REMARKS

37 C.F.R. § 1.83(a) (Drawings)

FIG. 10A

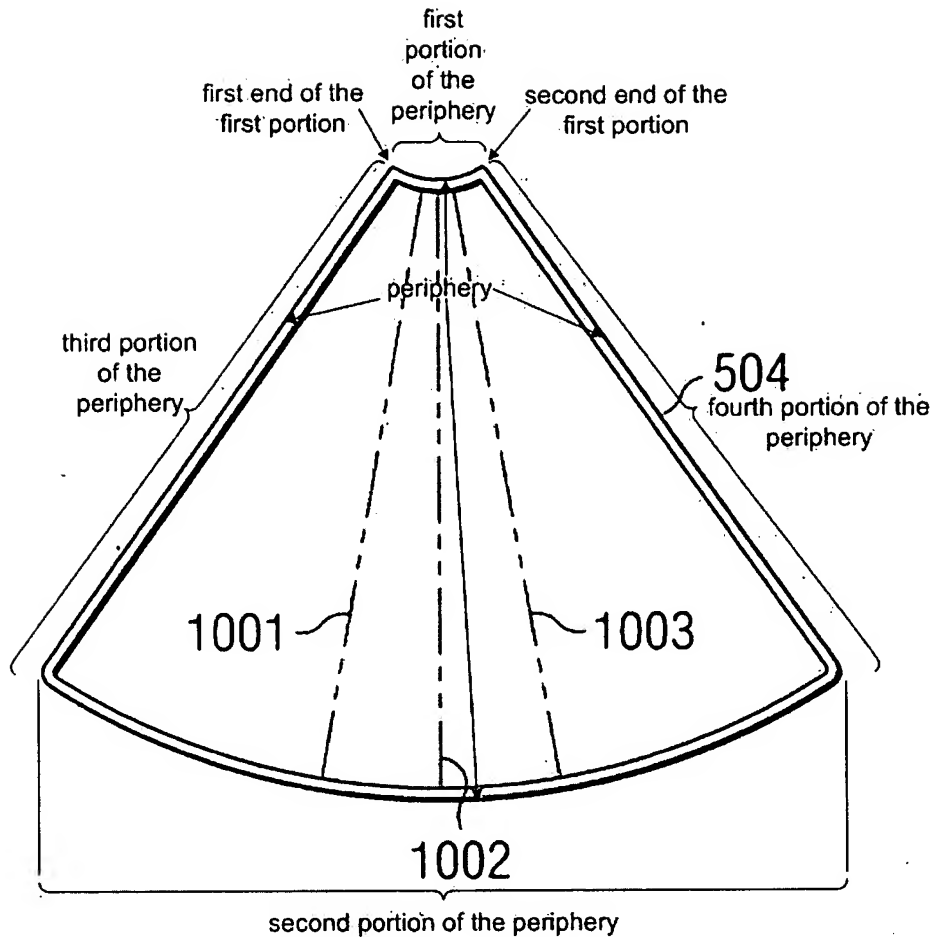
The drawings were objected to under 37 C.F.R. § 1.83(a) as failing to show every feature specified in the claims. This objection is respectfully traversed.

The Office Action asserts that the drawings fail to show “a periphery defined by a first portion having first and second ends and abutting the support along an entire length between the first and second ends when mounted, a second portion distal from the first portion, a third portion extending between the first end of the first portion and the second portion and a fourth portion extending between the second end of the first portion and the second portion” as recited in independent claims 1, 10 and 17.

An annotated copy of the plan view of a tray in Figure 10A follows:

As can be seen, the tray has “a periphery defined by a first portion having first and second ends and abutting the support along an entire length between the first and second ends when mounted, a second portion distal from the first portion, a third portion extending between the first end of the first portion and the second portion and a fourth portion extending between the second end of the first

portion and the second portion” as recited in the claims. It should be noted that the term “end” in the English language means, *inter alia*, “a point, line or limitation that indicates the full extent, degree, etc. of something.” See *Webster’s New Universal Unabridged Dictionary* (Barnes & Noble 1996) at page 641, definition 2 (copy attached). The periphery of the tray depicted includes such “ends” of the portion following the uppermost arc.

Therefore, the objection to the drawings under 37 C.F.R. § 1.83(a) has been overcome.

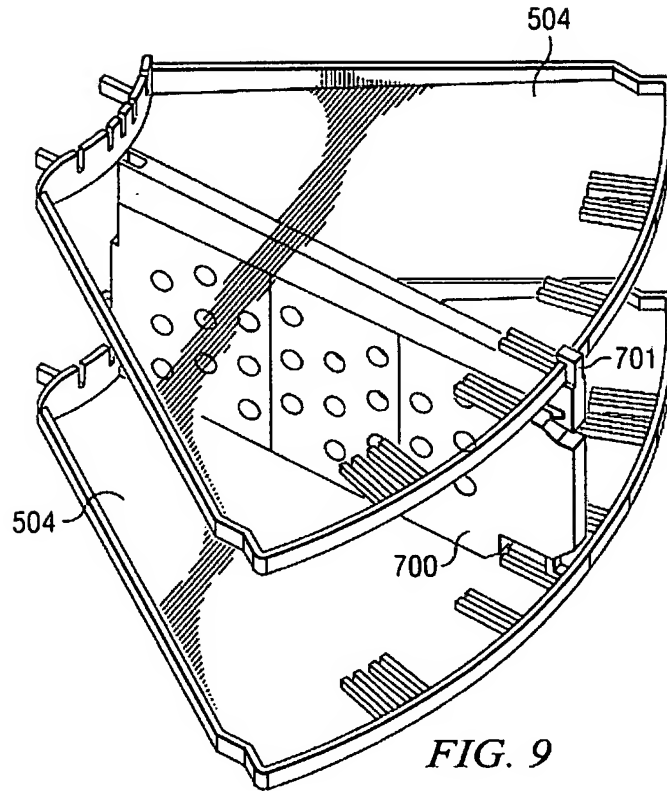
Claims 1, 10 and 17 were rejected under 35 U.S.C. § 112, second paragraph as being indefinite for failing to particularly point out and distinctly claim the subject matter regarded as the invention. This rejection is respectfully traversed.

It is unclear as to what end of a portion the applicant is referring to. [sic] In particular, as seen in applicant [sic] Figure 9 the portion do not [sic] end within any contained partitions. Appropriate action is required.

Paper No. 20071001, pages 3–4. However, the periphery of the trays depicted in Figure 9 includes a portion that follows an inside arc abutting the center support when mounted, and that portion of the periphery terminates (ends) where the periphery changes to extending in a radial direction:

Therefore, the rejection of claims 1, 10 and 17 under 35 U.S.C. § 112, second paragraph has been overcome.
